ECE/TRANS/WP.29/GRSG/2009/19  
10 August 2009

**REGULATION No. 46  
(Devices for indirect vision)**

Proposal for draft amendments to Regulation No. 46

Submitted by the expert from the United Kingdom \*/

**Figure 8c - Required field of vision for passenger side"**

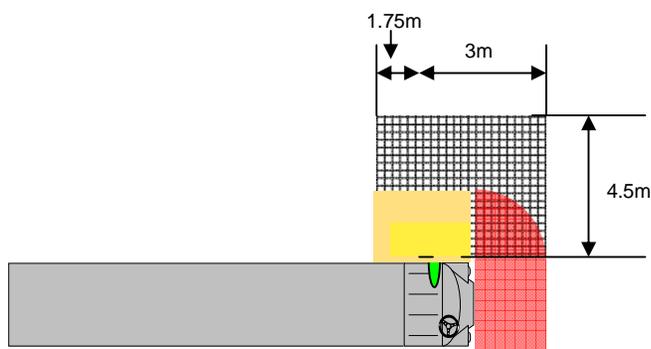
Insert new paragraphs 15.2.4.5.6. to 15.2.4.5.9.( including new Figure 8c), to read:

- "15.2.4.5.6. on the passenger side only, the field of vision described in paragraphs 15.2.4.5.1. to 15.2.4.5.5. shall be extended by means of any device, or combination of devices, such that the driver can see a flat horizontal portion of the road along the side of the vehicle, bounded by the vertical planes defined in Figure 8c.**
- 15.2.4.5.7. in the transverse direction, the parallel plane passing at a distance of 4.5 m in front of the plane mentioned in paragraph 15.2.4.5.1.**
- 15.2.4.5.8. to the rear, the plane parallel to the vertical plane passing through the driver's ocular points and situated at a distance of 1.75 m behind that plane.**
- 15.2.4.5.9. to the front, the plane parallel to the vertical plane passing through the driver's ocular points and situated at a distance of 3 m in front of that plane.**
